Record of Executive Business and Chief Executive's Order

Reg. Reference: SD22A/0039 **Application Date:** 10-Feb-2022
Submission Type: Additional **Registration Date:** 25-Aug-2022
Information

Location: Silveracre Bungalow, Whitechurch Road,
Rathfarnham, Dublin 14.

Applicant Name: Dungrey Limited

Figure 3 footpath

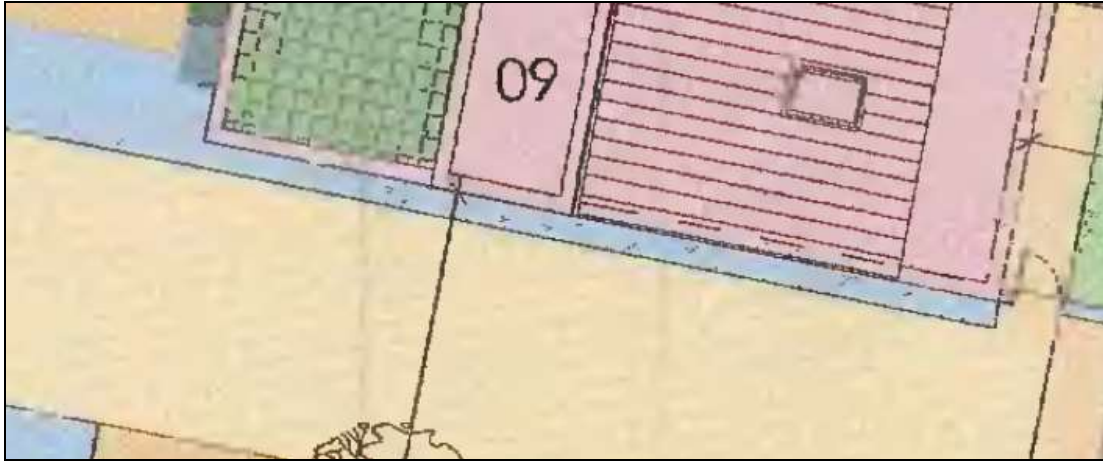
It is proposed to provide a 1.8m wide footpath along the front of the development along Whitechurch Road, this must connect to existing walking infrastructure. The existing walking and cycling infrastructure along Whitechurch Road are very poor and improvements are welcomed. The footpath is narrow 0.7m in places. There is no footpath to the north towards Ballyboden Road/Willbrook Road, potentially the strongest pedestrian desire line towards Rathfarnham Village and public transport. There is a potential pedestrian route through Willbrook Grove towards Ballyboden Road, that could be accessed by uncontrolled pedestrian crossing from the proposed development across Whitechurch road over the bridge at the whitechurch stream.
